# Town of Leicester PLANNING BOARD

## PLANNING BOARD AGENDA WEDNESDAY September 22, 2021 @ 7:00PM

## Memorandum

**TO:** Planning Board Members  
**FROM:** Michelle R. Buck, AICP  
Town Planner/Director of Inspectional Services  
**DATE:** September 2, 2021  
**RE:** **September 7, 2021 Planning Board Meeting**

EROSION CONTROL PLAN  
PREPARED FOR: SCHOLD DEVELOPMENT, LLC (OWNER/APPLICANT)  
77 CHICKERING ROAD, SPENCER, MA 01562

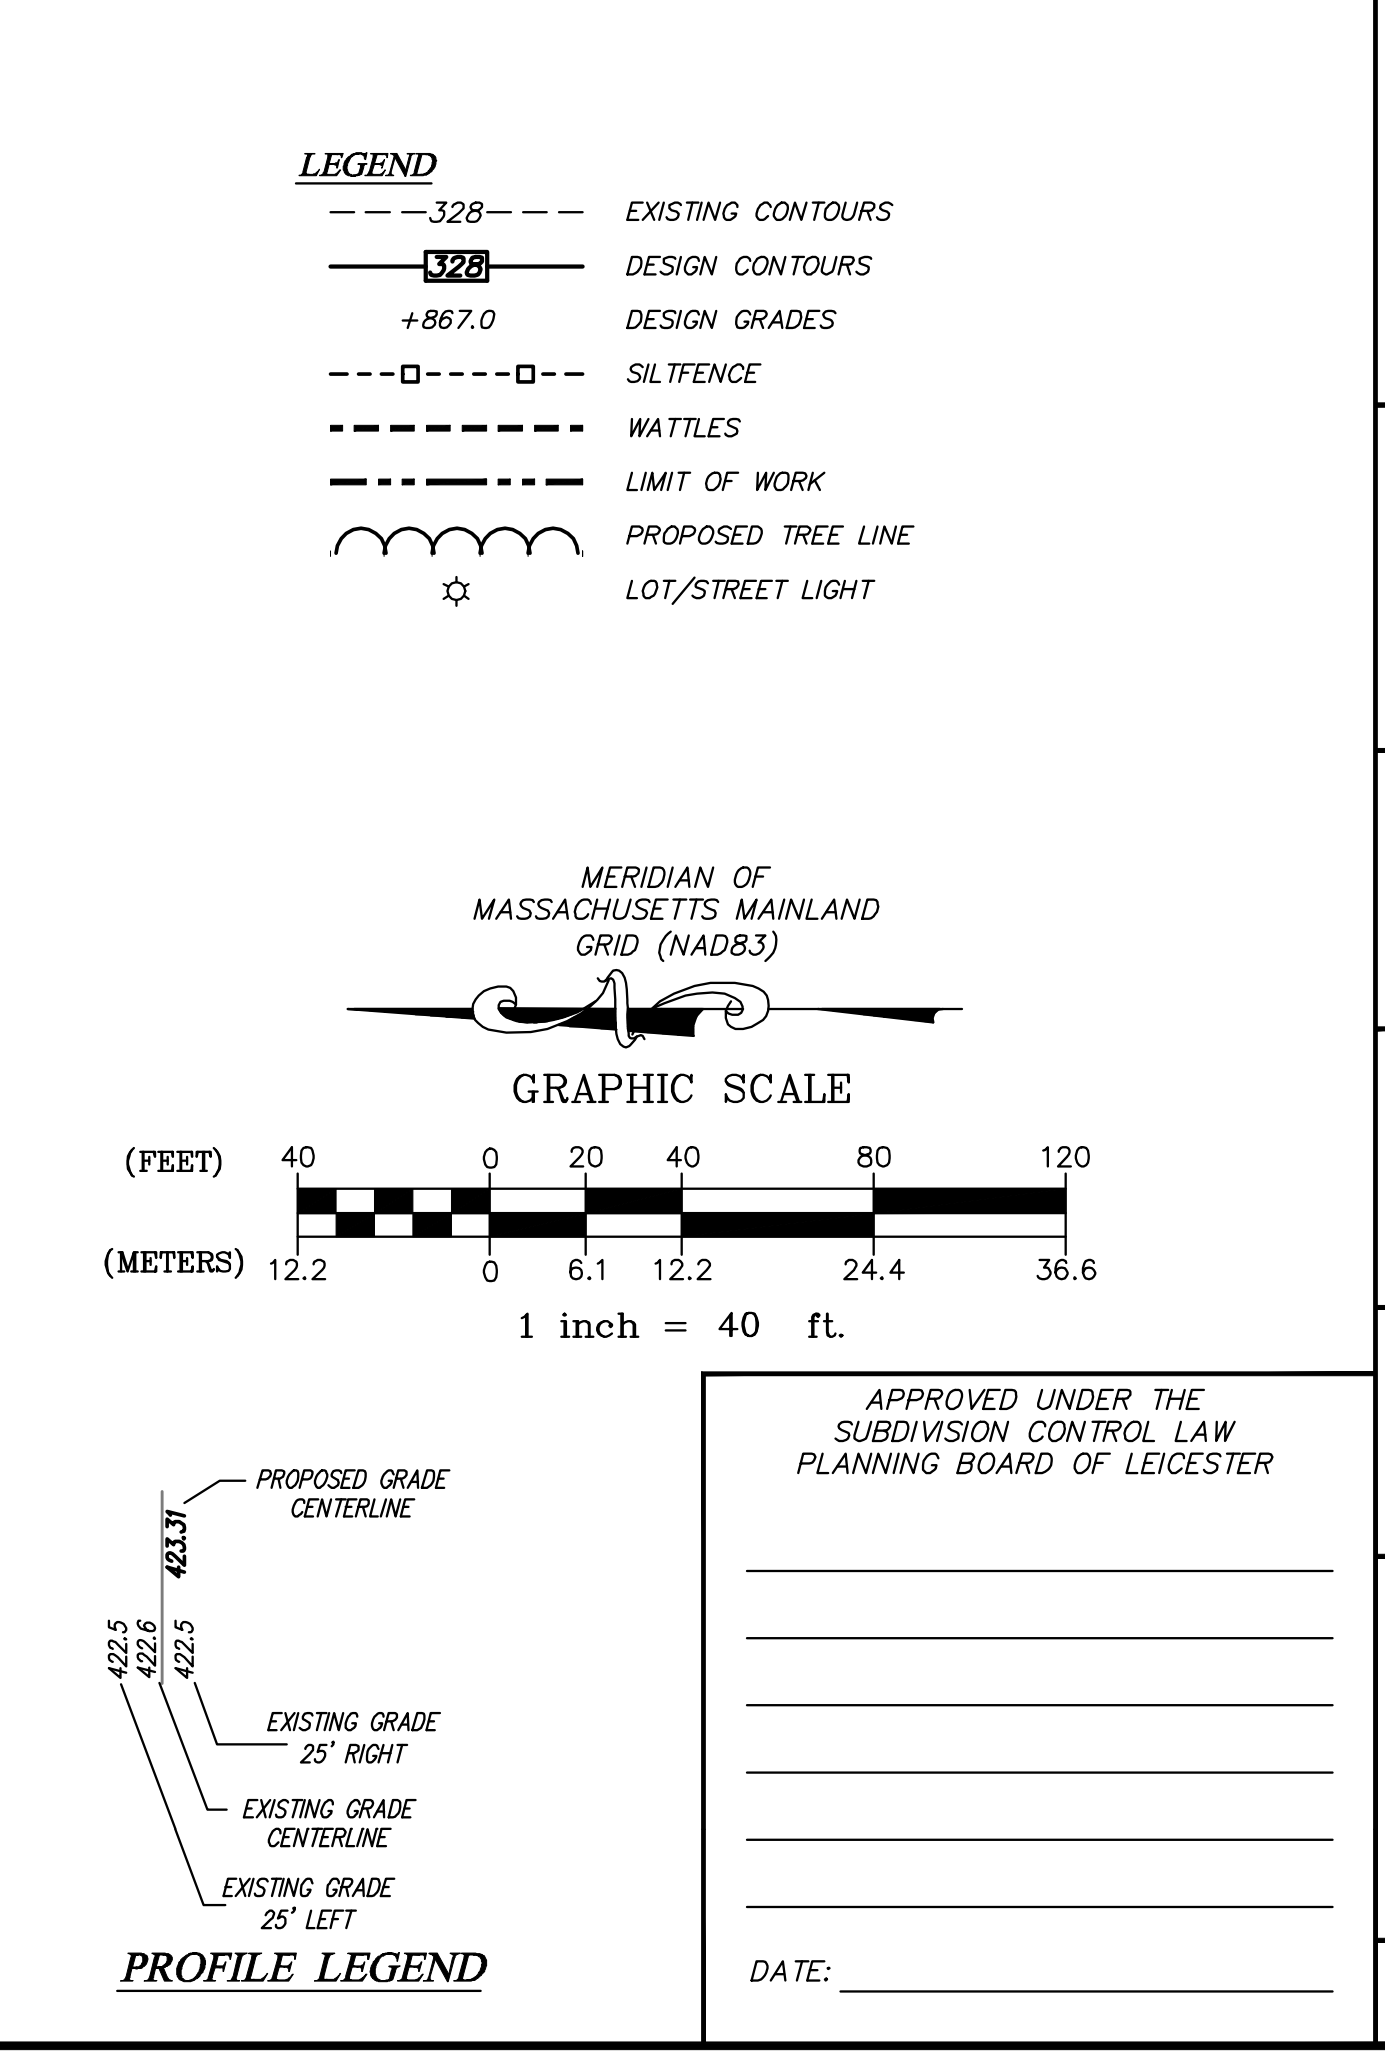
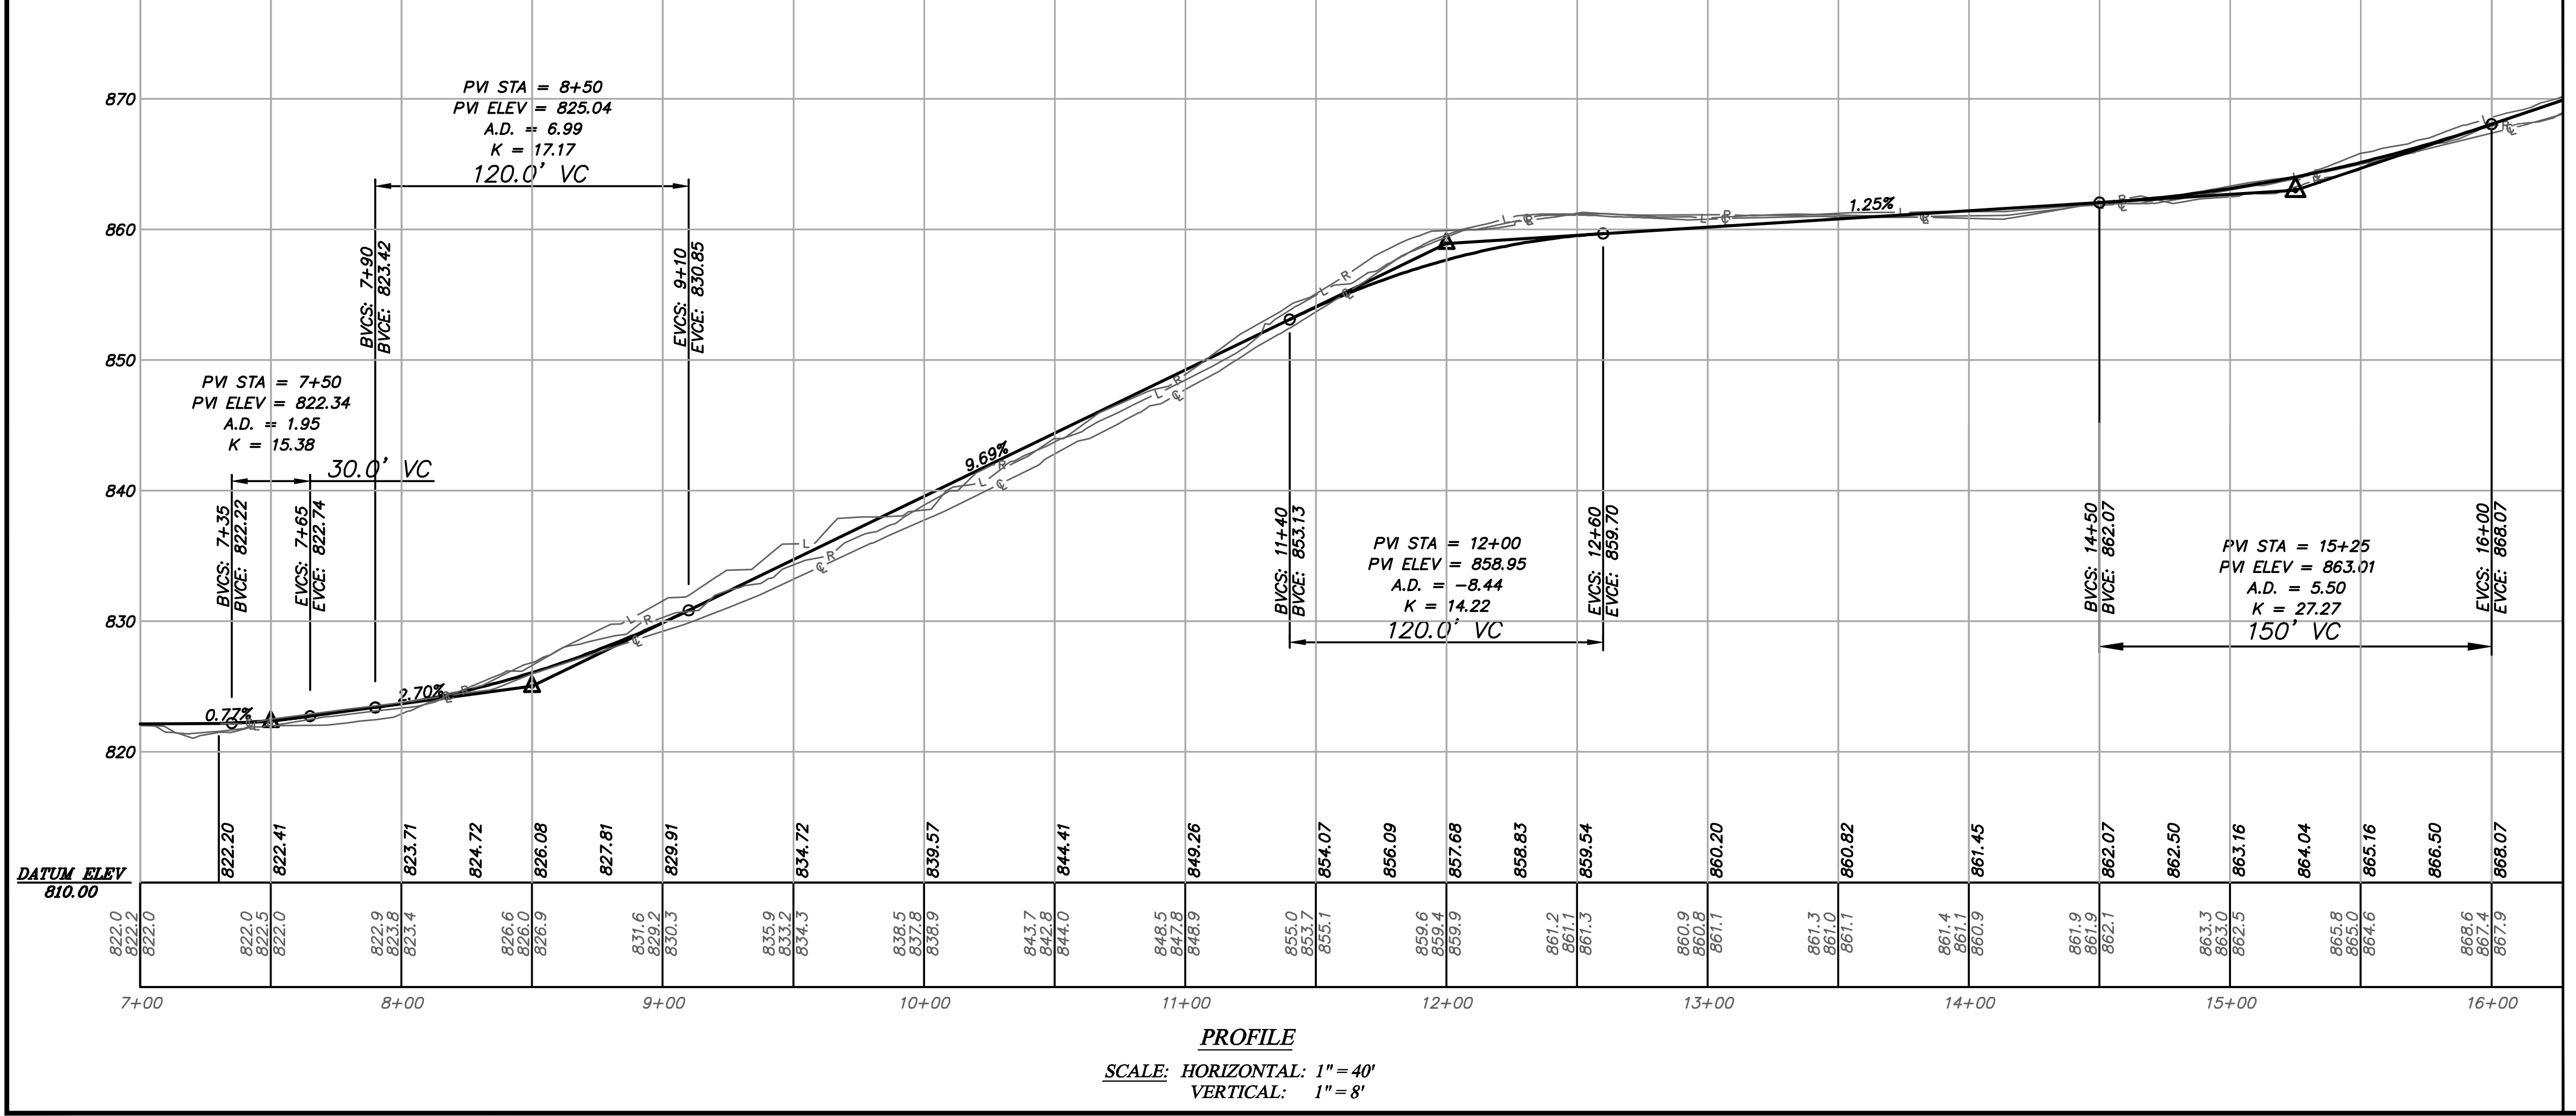
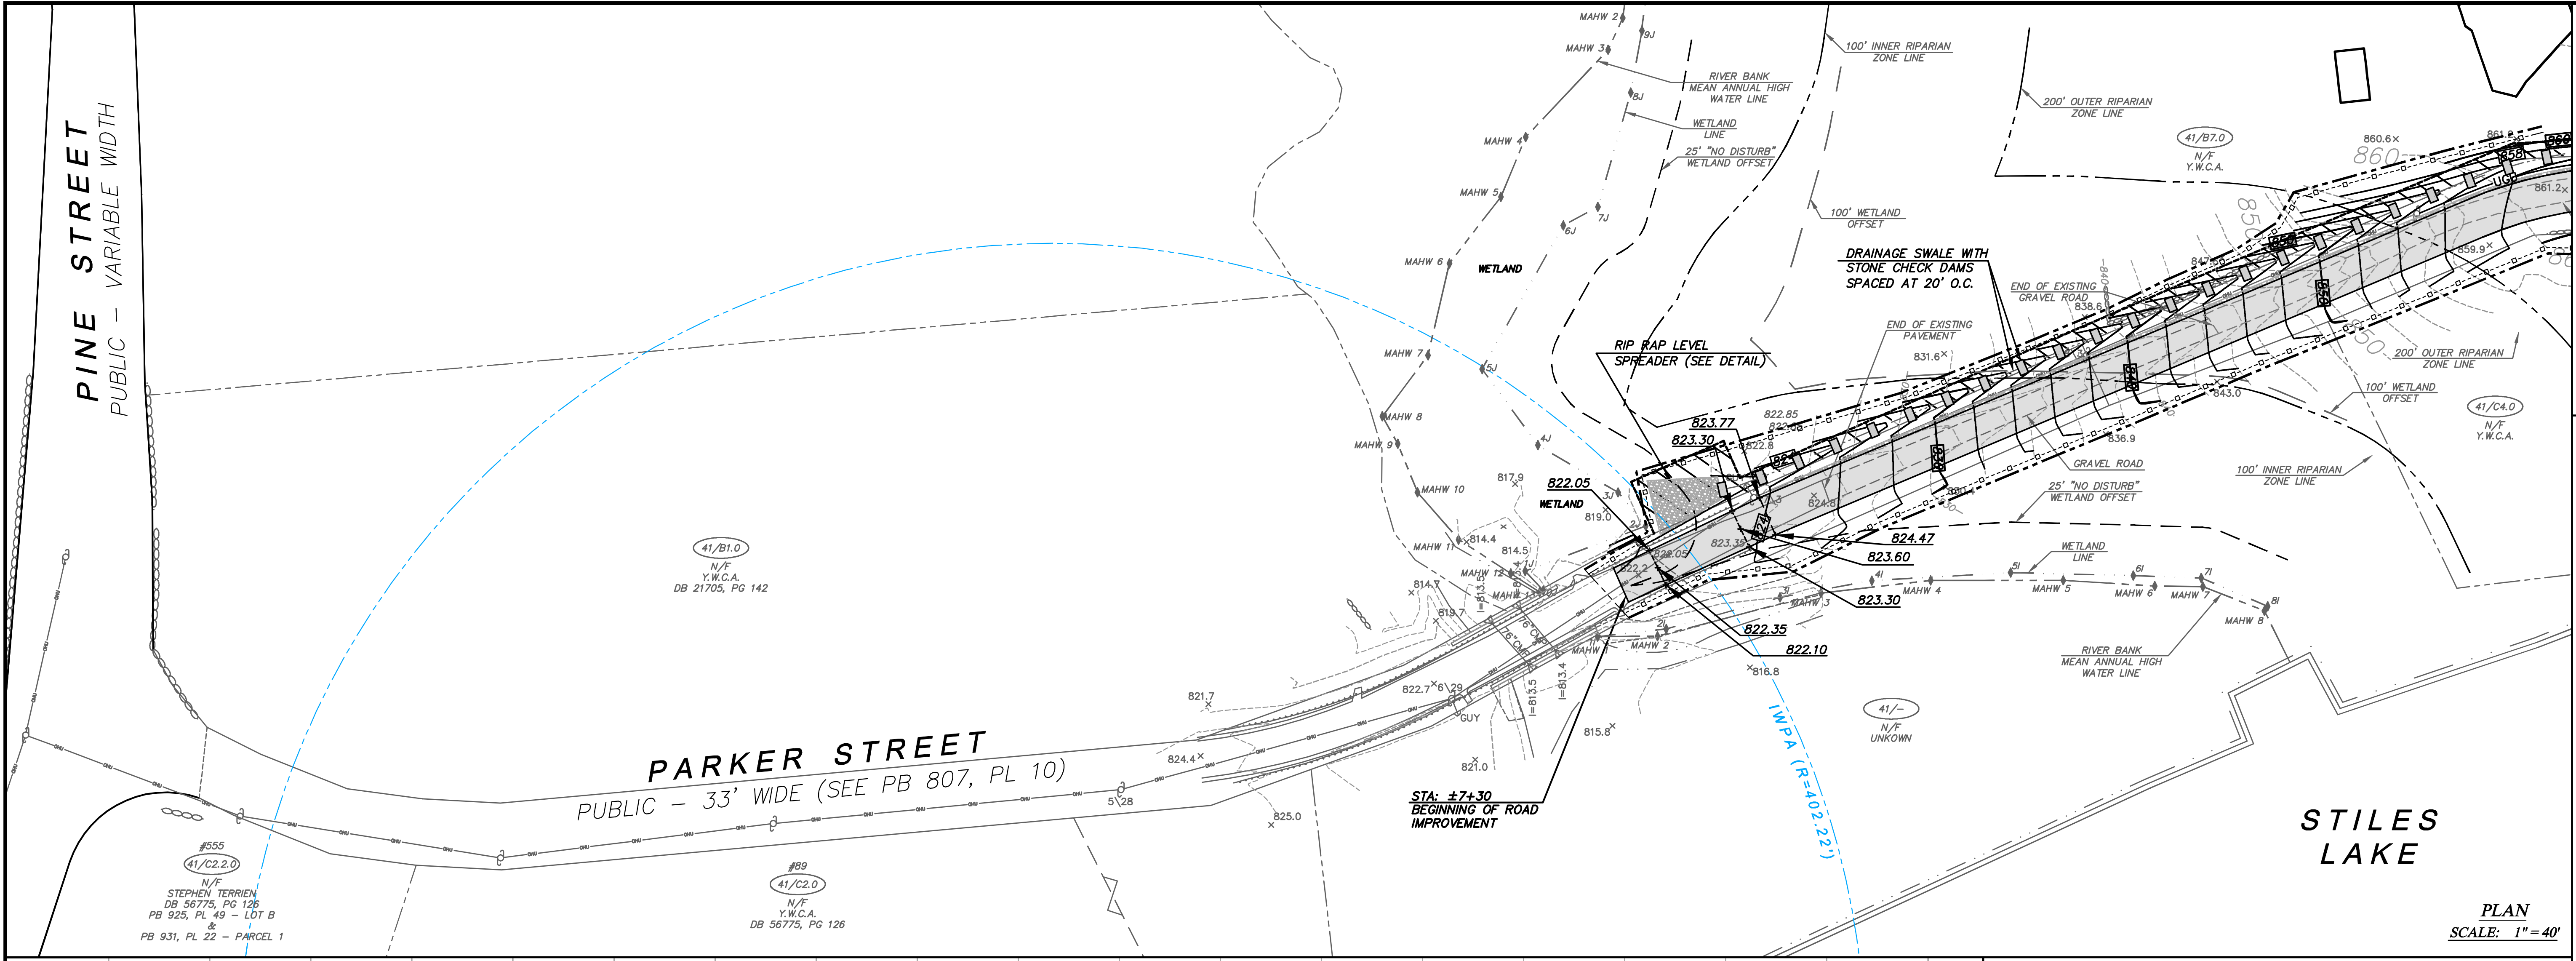
2. **Sheet 2: No Changes**
3. **Sheet 3: Added drainage easement detail to include the drainage swale along the easterly side of the existing Parker Street right-of-way located on the lands of the Y.W.C.A. and updated the easement area notation.**
4. **Sheet 4: Updated Infiltration Basin B1 location and grading as noted in Hydrology & Stormwater #6 above.**
5. **Sheet 5: No Changes.**
6. **Sheet 6: Updated Infiltration Basin B1 location and grading as noted in Hydrology & Stormwater #6 above.**
